SUBJECT: Forwards Tech Spec Figures 6.2-1 & 6.2-2 outlining organizational changes to replace Tech Spec submitted; w/840515 application to amend License DPR-67 & 840521 application to amend License NPF-16.

August 26, 1985
L-85-330

Re: St. Lucie Unit Nos. 1 & 2
Docket Nos. 50-335 & 50-389
Proposed License Amendment
Organization and Event Reporting

FIGURE 6.2-1
OFF-SITE ORGANIZATION FOR FACILITY
MANAGEMENT AND TECHNICAL SUPPORT

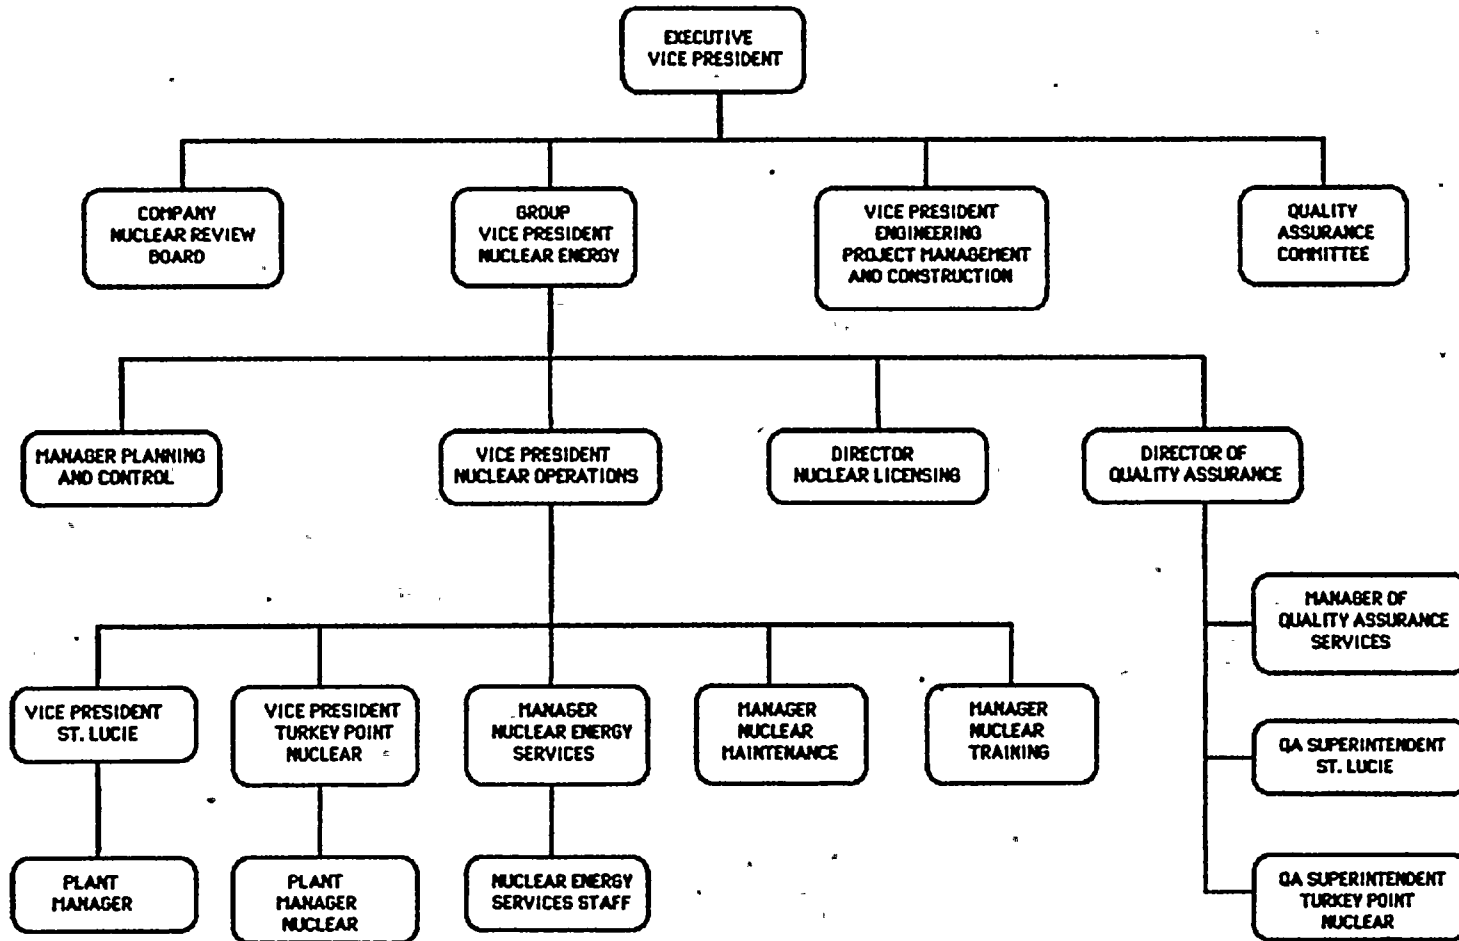
During the time from our original application to present, a number of organizational changes have occurred that would make the organizational changes previously submitted out of date. Therefore, attached are Technical Specification Figures 6.2-1 and 6.2-2 for both St. Lucie Units 1 and 2. We request that these updated figures be included with the forthcoming license amendments.
